Vermont Agency of Transportation
RECEIVED
 CK'D BY TM, JW, NVDB, KM, RK OK'D BY JG
 April 12, 2017
 RESUBMIT No Approved AsNoted
 BY K. Higgins DATE 04/13/17

CALDERWOOD ENGINEERING, ETC.
 STRUCTURAL ENGINEERING • DETAILING SERVICES
 222 RIVER RD., RICHMOND, ME 04357 PH/FX (207) 731-2007 / 737-2008
 PREPARED FOR: MILLER CONSTRUCTION
 STRAFFORD BF 01777(10)

STRAFFORD VERMONT
 ABUTMENT SHOP DETAILS
 PBU-2 DIMENSIONAL DETAILS

SHEET NUMBER
3

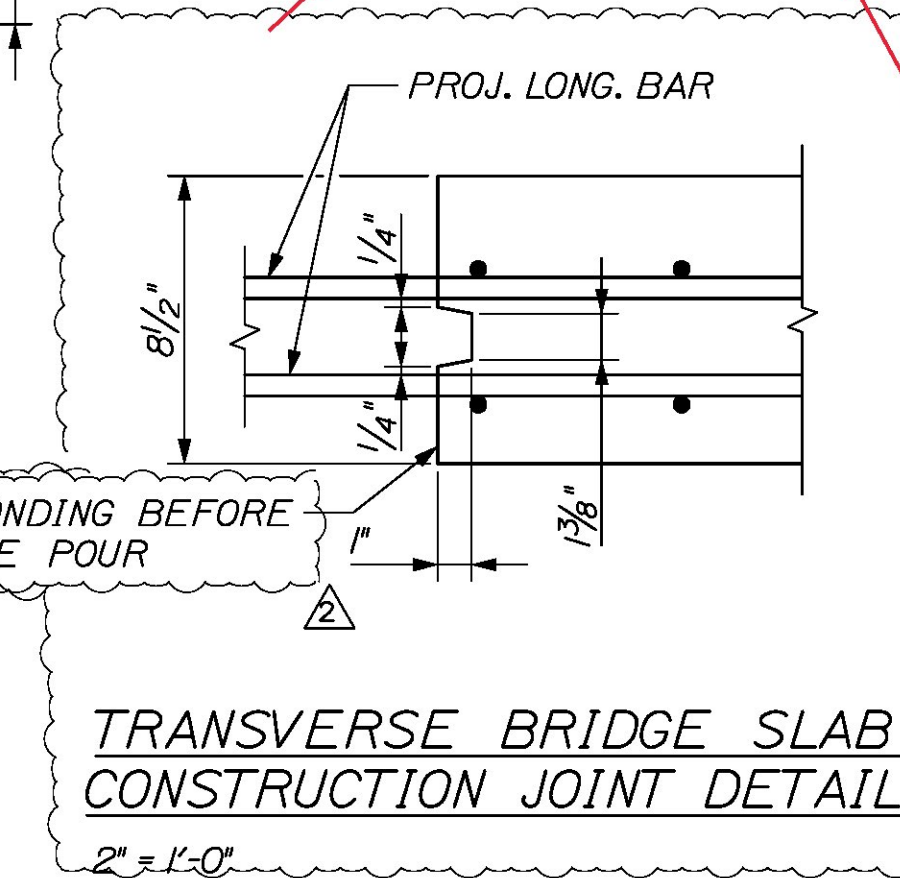
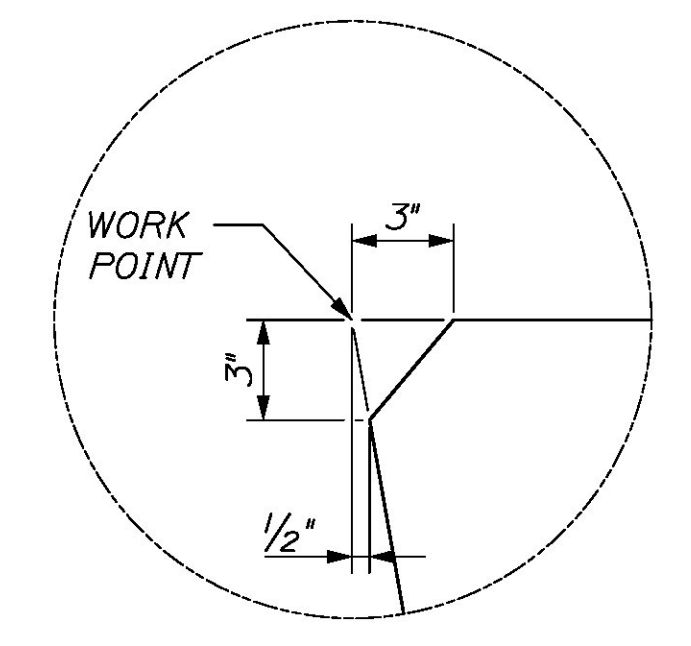
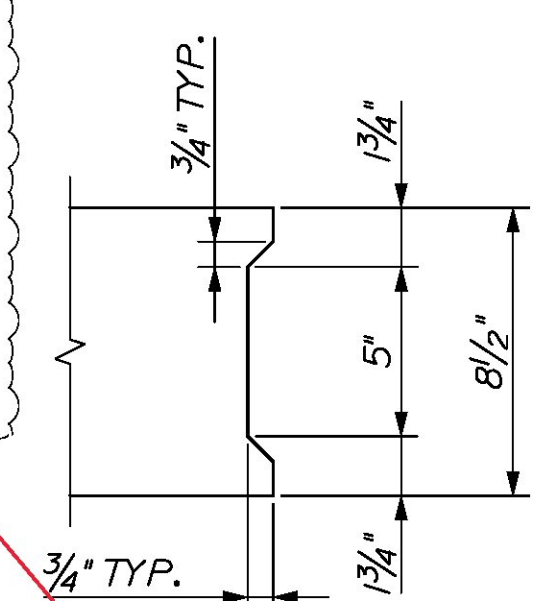
This information is unnecessary as Beam Profiles will need to be submitted prior to forming.
